# June 2022 Product Shipping Configuration Change Notice For Poly VVX Phones

Engineering Advisory 210826

June 2022 | 3725-47130-013C

## Example VVX 350 Console Label and Revision Code

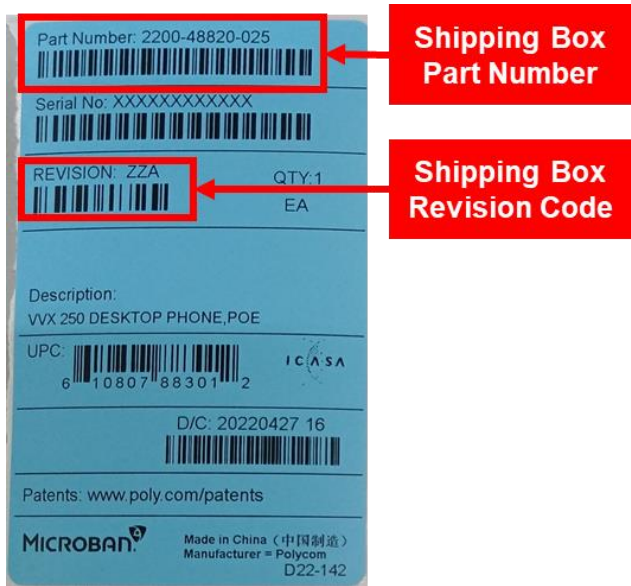
You can determine whether your phone includes the new hardware changes and software by examining the color of the shipping label, the part number and console revision listed on back of the phone, and the part number and console revision listed on the shipping boxes, as shown in the following figures.

### Example VVX 450 Web Configuration Utility

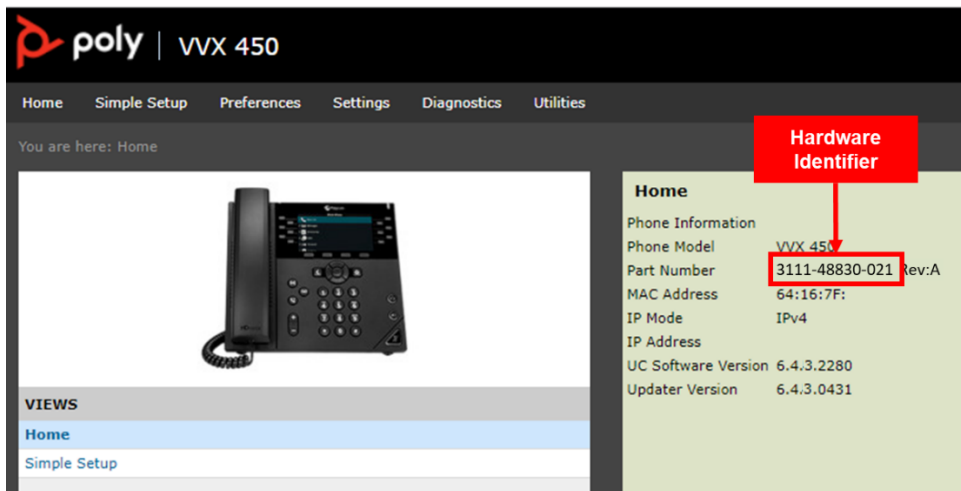
You can also identify a phone with the new hardware revision by examining the Hardware Identifier displayed in the phone's Web Configuration Utility and Phone UI as shown in the following figures.
